Sneak Circuit Analysis of F-4C Flight Control System

D2-118545-1

F-4C

F33657-74-C-0686

FIGURE 2

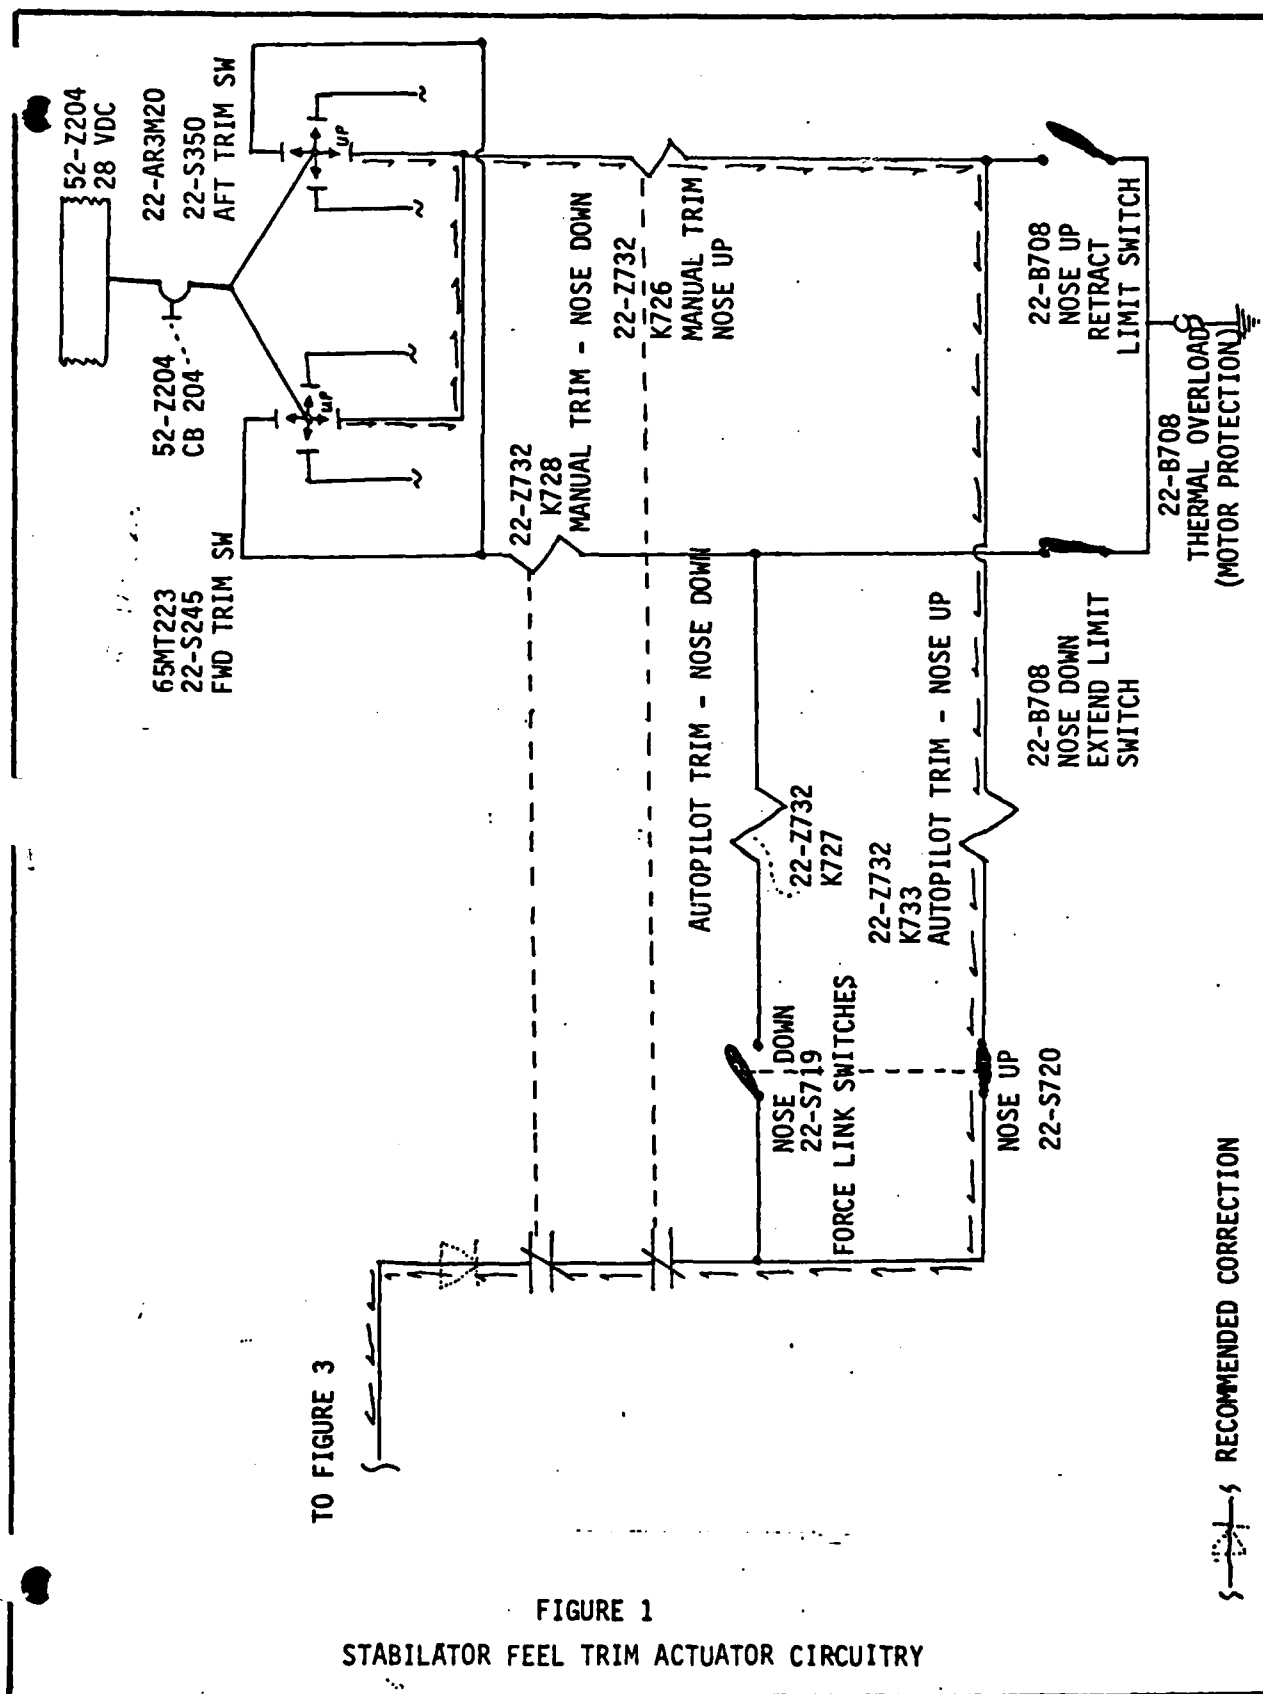
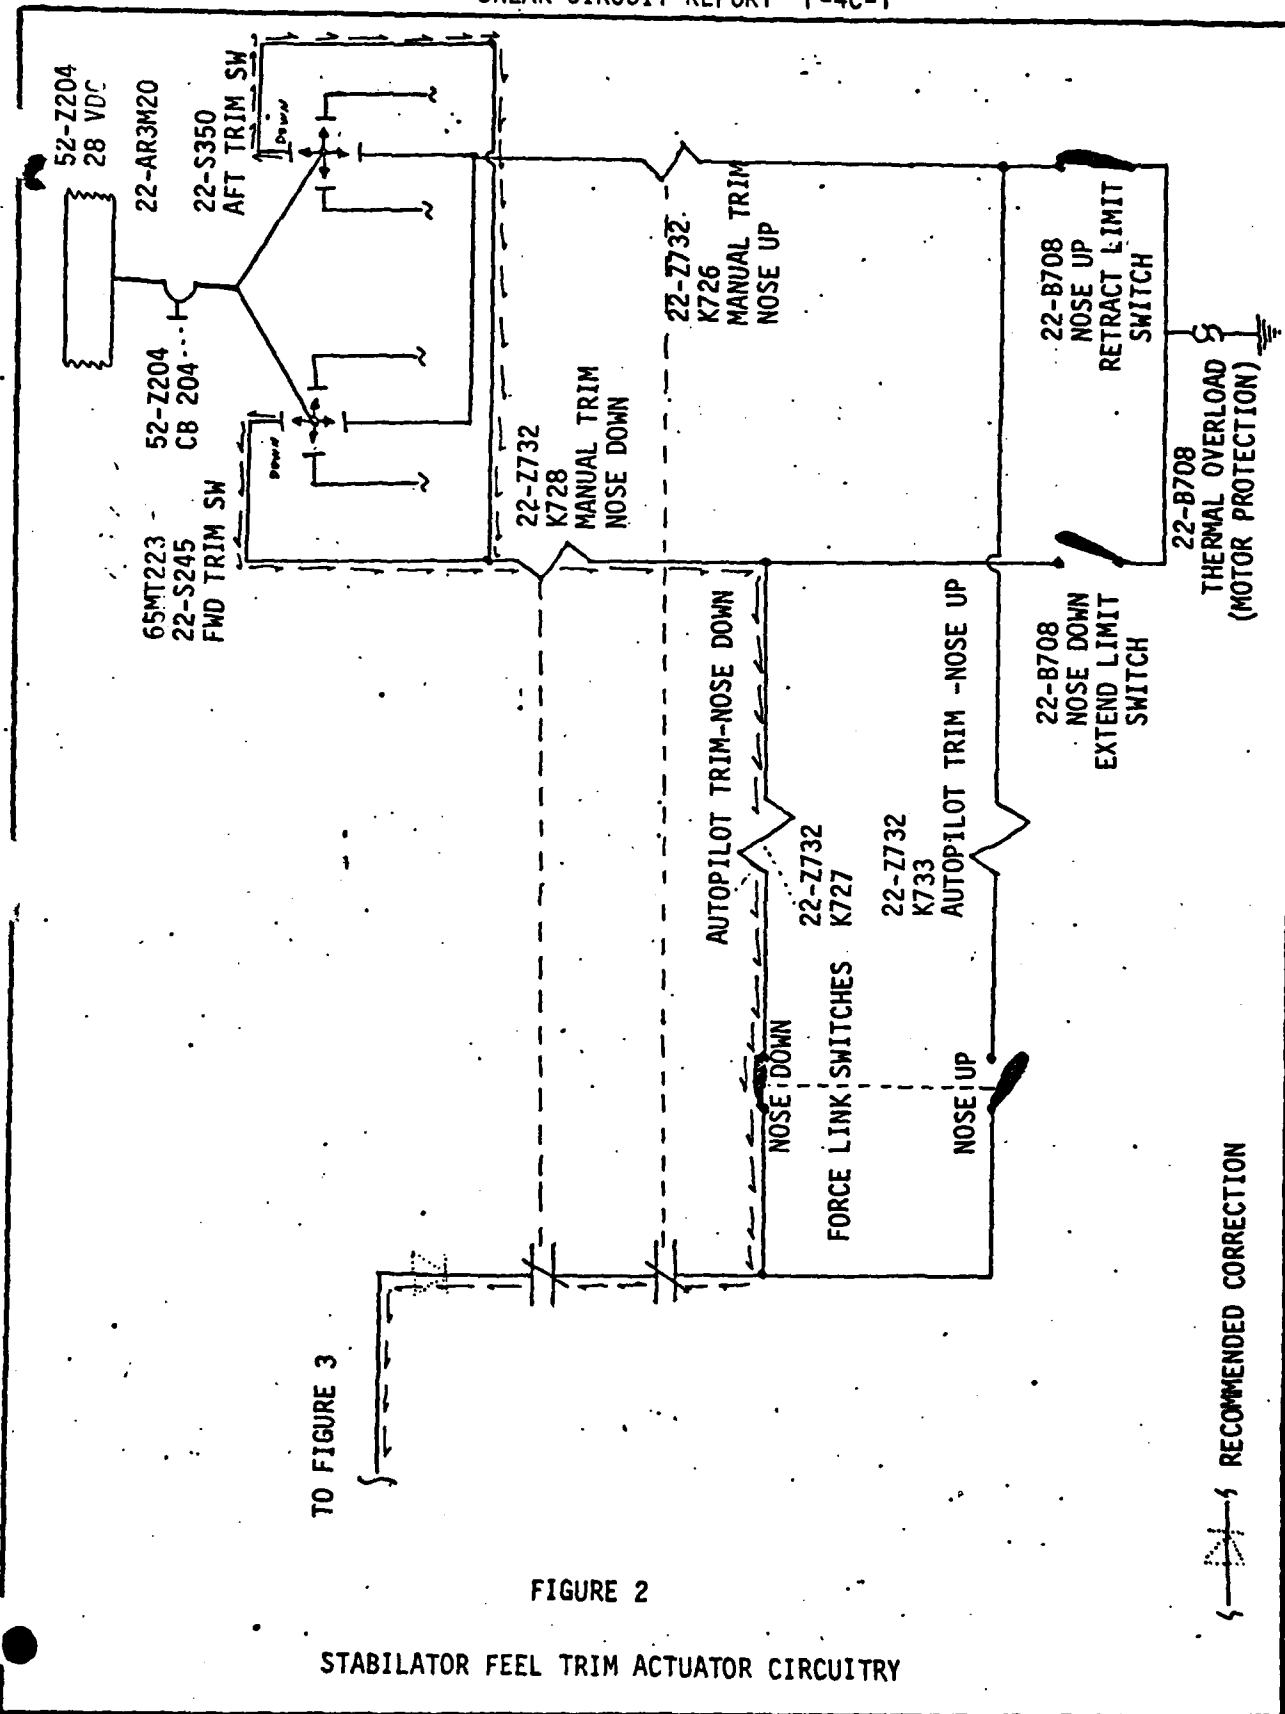
When the Stabilator Feel Trim Actuator Motor reaches its retract limit, the Nose Up Retract Limit Switch in ref. des. 22-B708 opens as shown in figure 1. If the FWD Trim Switch (22-S245) in ref. des. 65-MT223 or the AFT Trim Switch (22-S350) in ref. des. 22-AR3M20 is pushed to the UP position when either control stick is pulled back, the Trim Nose Up Force Link Switch (22-S720) is closed and the sneak path shown in figure 1 is established. Current will flow only when AFCS is disengaged. Current flows through the Manual Trim-Nose Up Relay (K726) in ref. des. 22-Z732 and through the Autopilot Trim Nose Up Relay (K733) in ref. des. 22-Z732. It then flows through the Force Link Switch and the Manual Trim Nose Up (K726) and Nose Down (K728) relay contacts. Current can then flow to ground by a number of paths depending on switch positions and relay contact closures discussed below. It is possible that relay K726 could be energized, causing relay chatter.

As shown in figure 2, a similar sneak path results when the Stabilator Feel Trim Actuator Motor reaches its extend limit and the Nose Down Extend Limit Switch in ref. des. 22-B708 opens. If a trim switch is then pushed to the Down position when either control stick is pushed forward, the Nose Down Force Link Switch (22-S719) is closed, current will flow through the Manual Trim-Nose Down Relay (K728) in ref. des. 22-Z732 and the Autopilot Trim-Nose Down Relay (K727) in ref. des. 22-Z732. Current could then flow to ground by the paths described below:

Add a diode in the location shown in Figures 1 and 2.

FIGURE 3

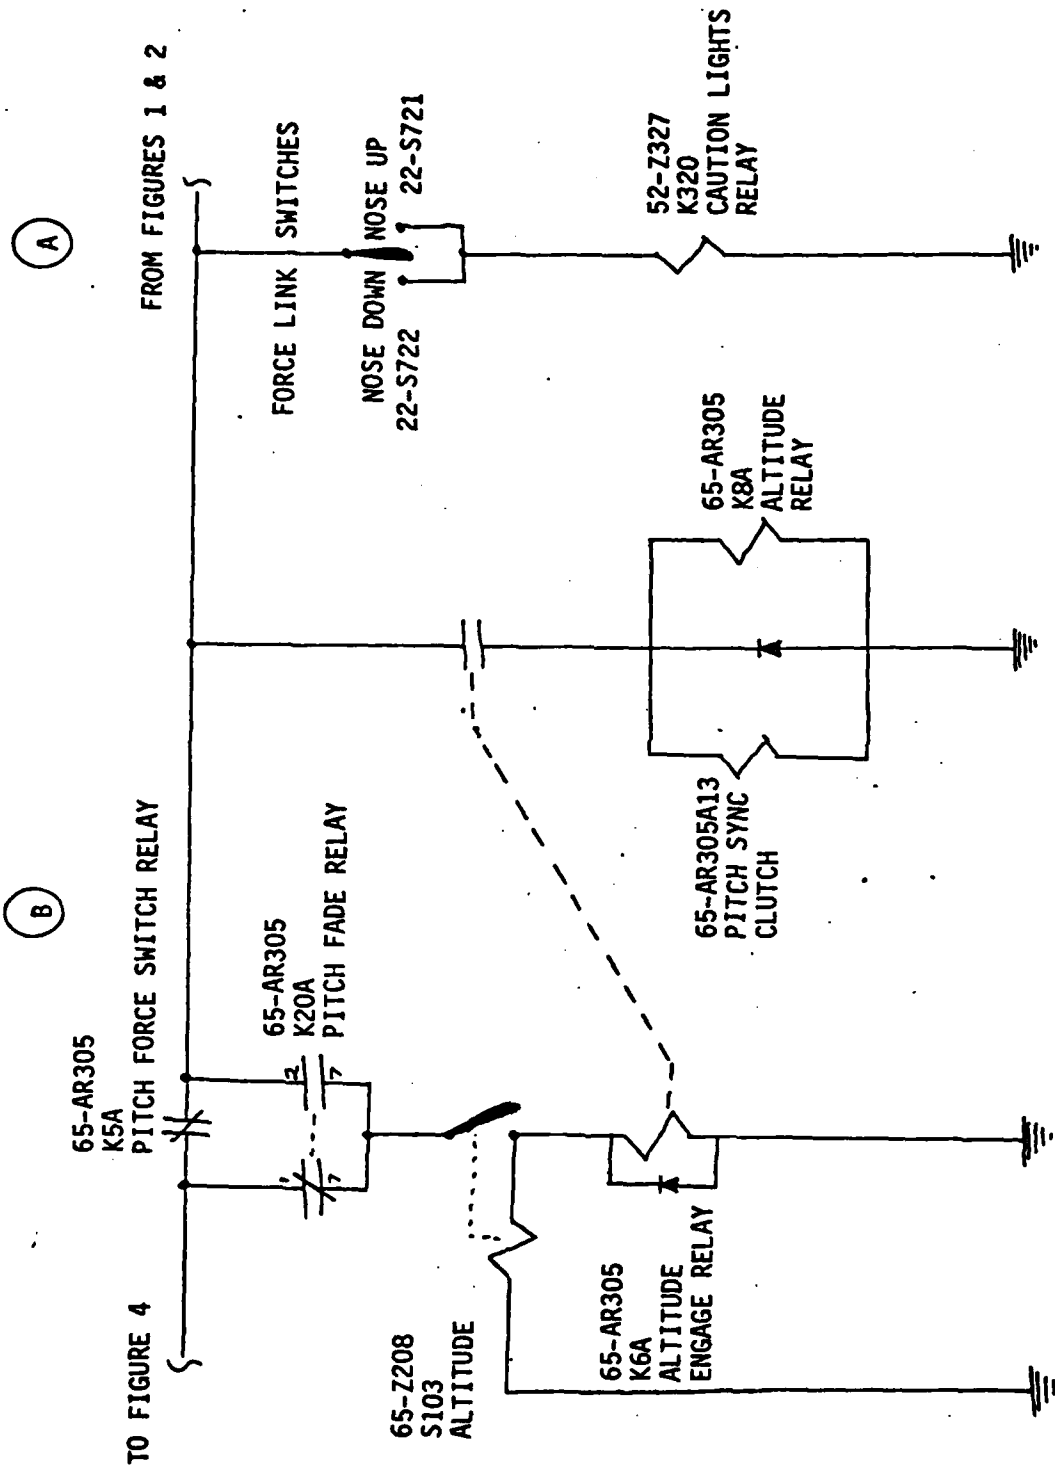
- Path A. As shown in Figure 3, if one of the 5 pound Warning Light Force Link Switches (22-S721 and 22-S722) is closed, power could be inadvertently fed to the Caution Lights Relay (K320) in ref. des. 52-Z327 which will turn on the A/P Pitch Trim Indicator, giving a false indication.

- Path E. As shown in figure 5, if the FWD or AFT Pitch Force Switch (S202) in ref. des. 65-MT223 is thrown, the Pitch Force Relay (K5A) may be energized. If it energizes, it would cause relay chatter since its contacts in figure 3 are between it and the power source.

FIGURE 4
AFCS RELAY SWITCHES

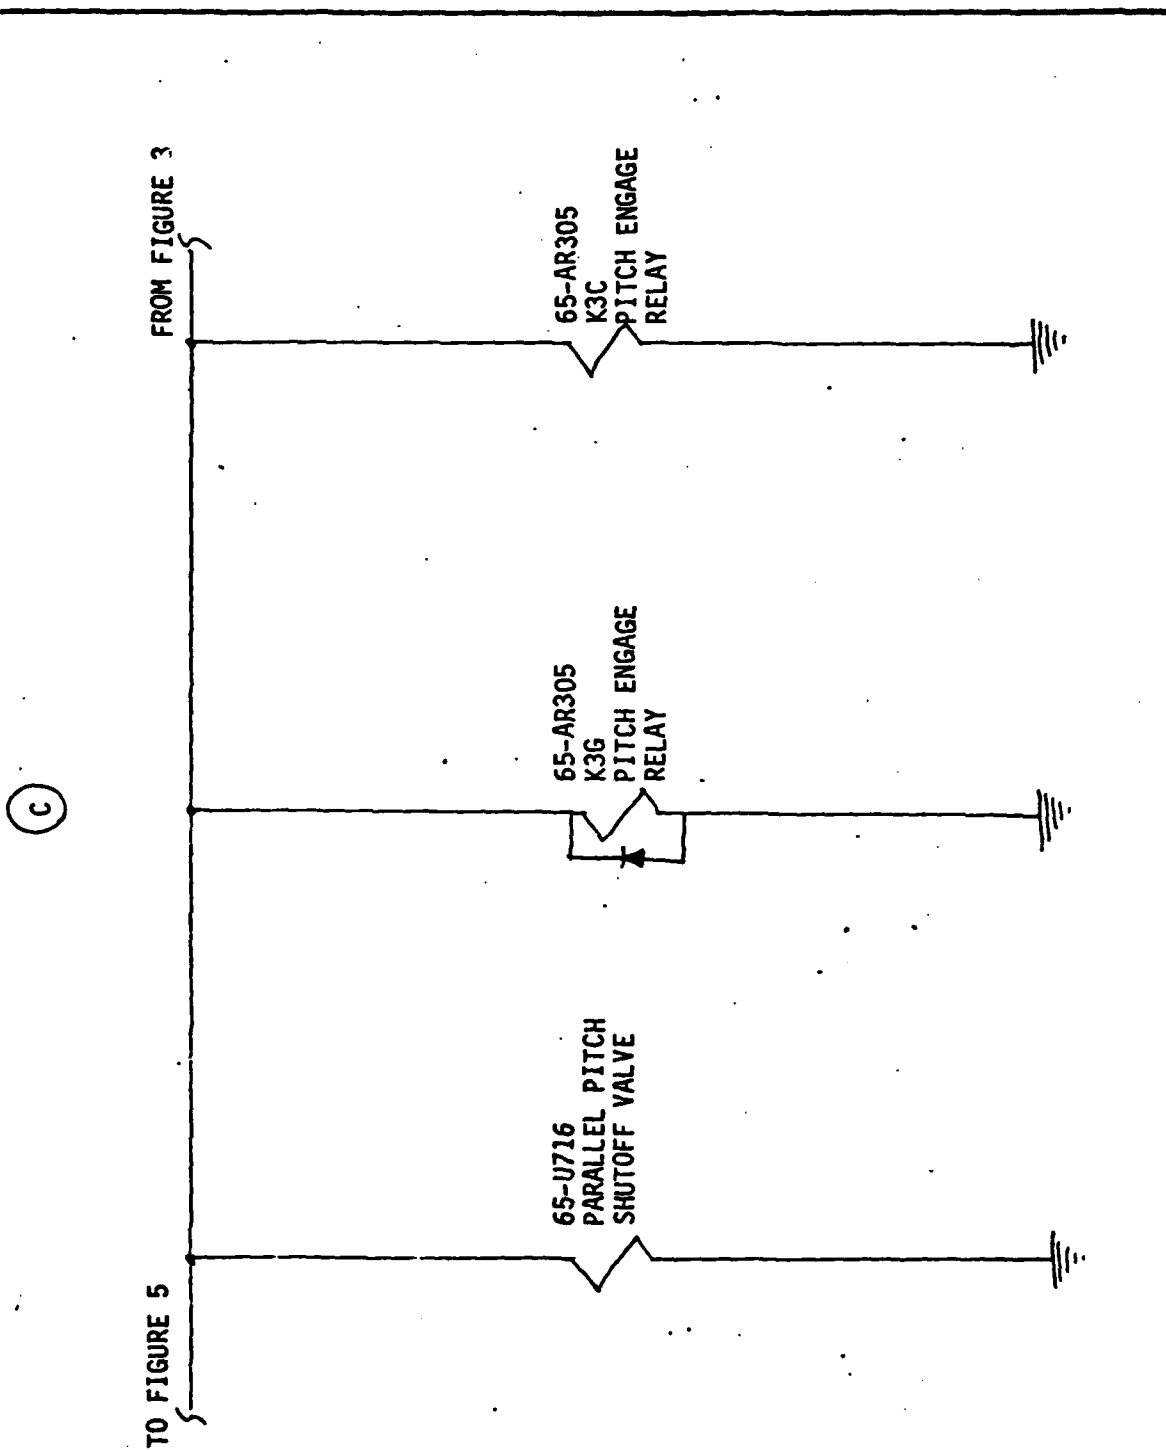
- Path C. As shown in figure 4, power can flow to the Parallel Pitch Shutoff Valve in ref. des. 65-U716 and to the Pitch Engage Relays (K3G and K3C) in ref. des. 65-AR305. This could cause the Pitch Channel of AFCS to be enabled even though AFCS is disengaged.

FIGURE 5
AFCS RELAY SWITCHING

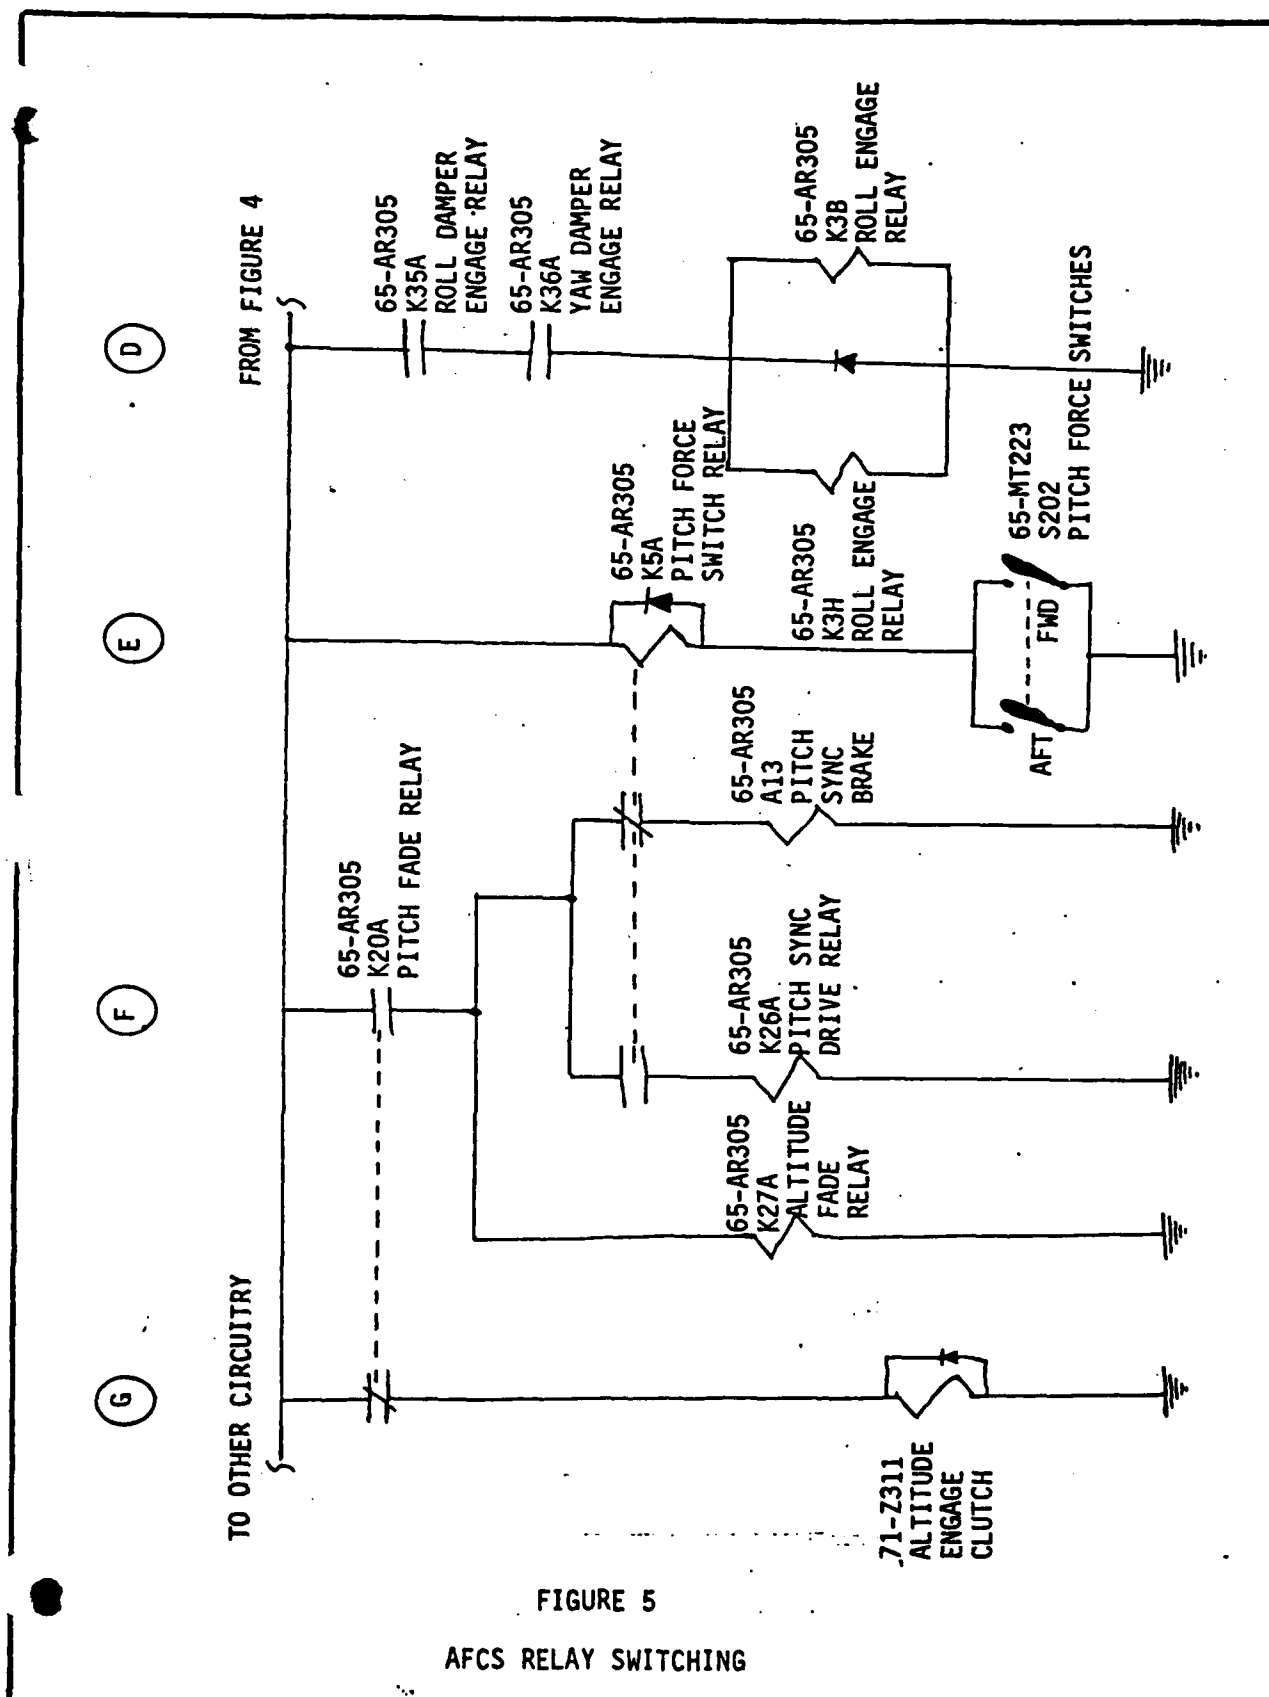
- Path F. If the Pitch Fade Relay (K20A) in ref. des. 65-AR305 is energized power is fed, as shown in Figure 5, to the Altitude Fade Relay (K27A) in ref. des. 65-AR305 and to the Pitch Sync Brake in ref. des. 65-AR305A13.

- Path G. As shown in figure 5, if the Pitch Fade Relay (K20A) is not energized, power is fed to the Altitude Engage Clutch in ref. des. 71-Z311.
